Ministry of Transportation
Nipigon River Bridge Independent
Technical Review

Nipigon River Bridge
Northwestern Region
Contract#: 2013-6000

September 2016

Figure 1-2: Fractured bolts (ASTM A490 bolt - connecting shoe plate to girder flange) and deformed shoe plate at north-west bearing. Note four lines of failed flange connection bolts.

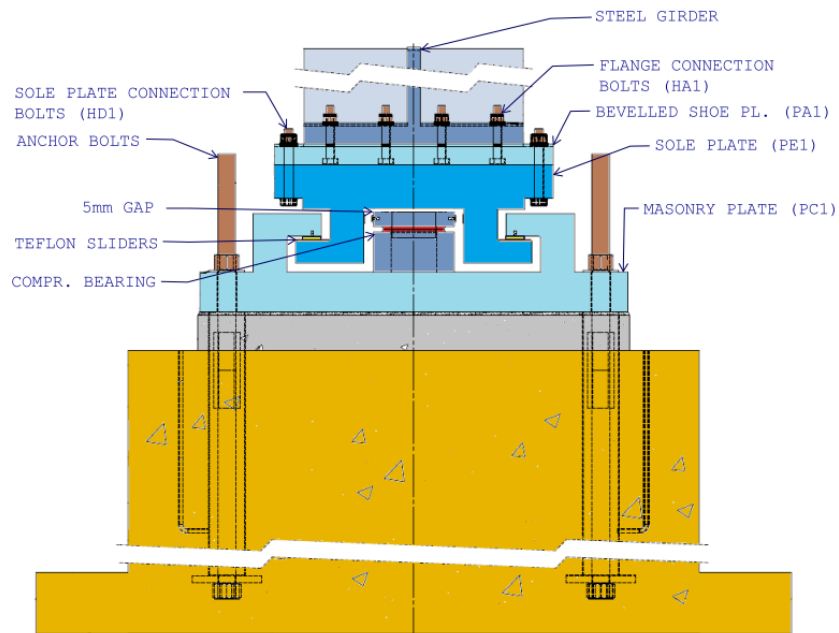
The cause of the tie down failure was a progressive fracture of the 40 (ASTM-A490) bolts connecting the bearing to the girder flange over the weeks and months prior to the complete fracture of the bolt group. While the bolt group failure was immediately apparent (as seen in Figure 1-2), the progressive nature of the bolt fractures and the contributing factors have been identified through examination and testing of the failed bolts and by the analyses and assessments described in this report.

2. The forces and strains in the outer two lines of bolts were increased significantly by flexibility of the tapered shoe plate and related prying effects between the bearing and the girder flange. In addition to the flexibility of the shoe plate, yielding and plastic strains also occurred in the shoe plate during the bolt fracture propagation. Yielding was evident in the permanent bend of the plate following failure. Both prying effects and plastic behaviour in the shoe plate contributed to increased strains in the bolts and the progression of the bolt fractures.
